Attachment 3 to AEP:NRC:0967L

Description of Ice Condenser Sublimation Calculation

Attachment 4 to AEP:NRG:0967L

Drawing of Ice Condenser Bay
and Row-Group Layout

ICE CONDENSER BAY AND
ROW-GROUP CONFIGURATION

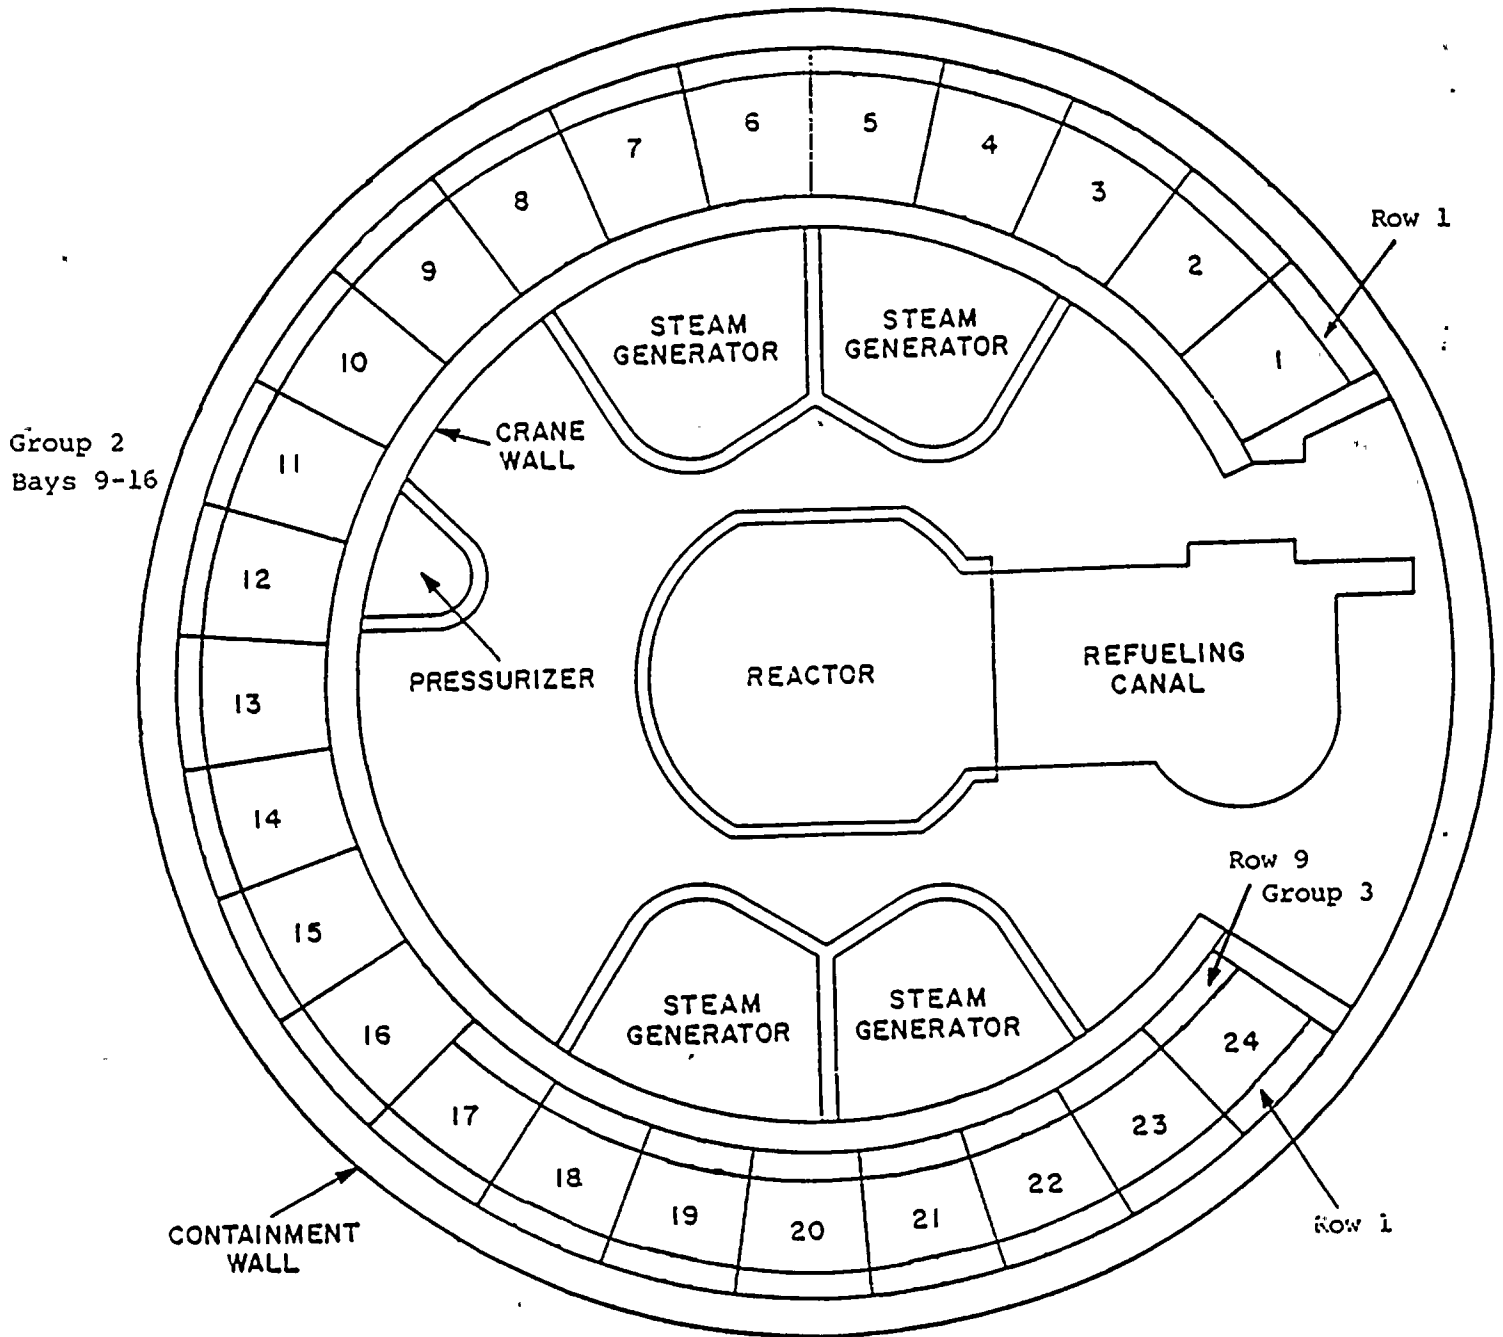
This section summarizes the calculations done in support of the surveillance extension request. The details of these calculations are available upon request. A pictorial description of the ice condenser arrangement is provided in Attachment 4.

Table 2 lists the "as-left" average ice basket weight for each row-group required to be weighed by T/S 4.6.5.1.b.2 and the expected weight in April 1989 at the lower 95 percent confidence level. All row-groups except Row 8 Group 3 and Row 9 Group 3 are expected to have average basket weights above 1220 pounds at the lower 95 percent confidence level. Row 8 Group 3 and Row 9 Group 3 are expected to have average basket weights above 1098 pounds at the lower 95 percent confidence level.
